LAND ADJACENT TO 9 ADDISON ROAD
SANDFIELDS, PORT TALBOT
SA12 6HJ

FLOOD CONSEQUENCES ASSESSMENT

MAY 2025

Report revision P1

Figure 9 – NRW Product 6 – 0.1% AEP Fluvial event - map extract

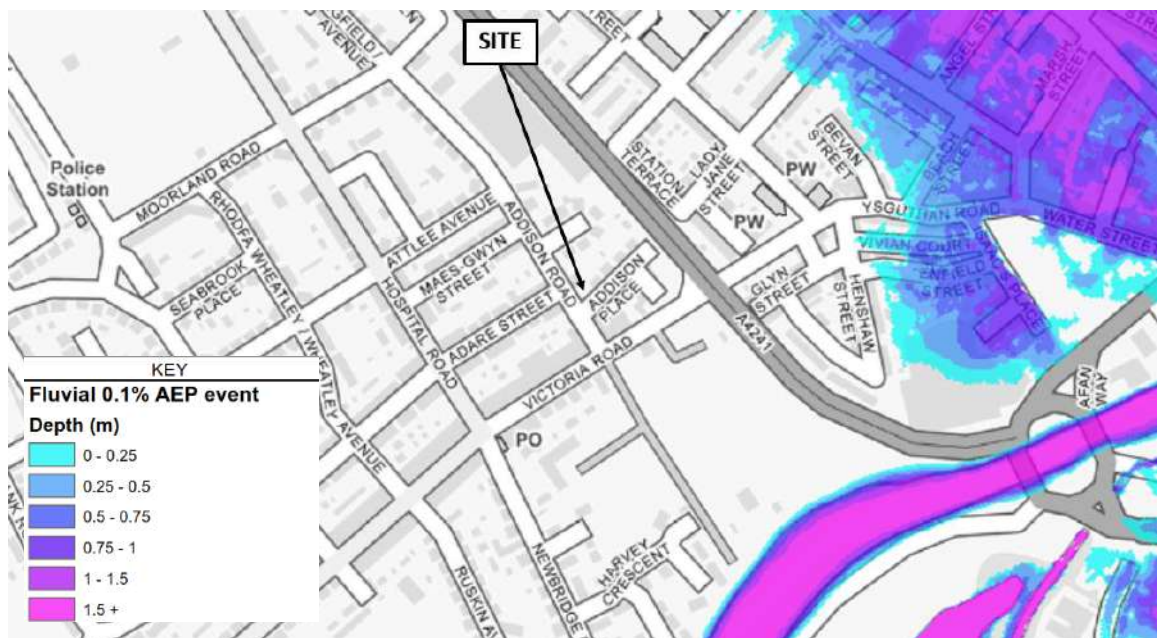
the data submitted on figure 9 (page 9) of the FCA by Meridian is not considered to be suitable for use of informing an FCA. At present the latest information held by NRW showing the flood risk to the site is Flood Map for Planning which is shown on page 8 (Figure 7) of the FCA where the site is considered to be at flood risk in the 0.1%AEP.

Therefore, our previous concerns relating to increased flood risk elsewhere as result of the proposed development still remain and we are unable to confirm that A1.12 of TAN15 can be satisfied.

In response, MCEC have added Section 7.3 to this FCA report which addresses the concerns of floodplain displacement which were not considered suitable in the previous revision.
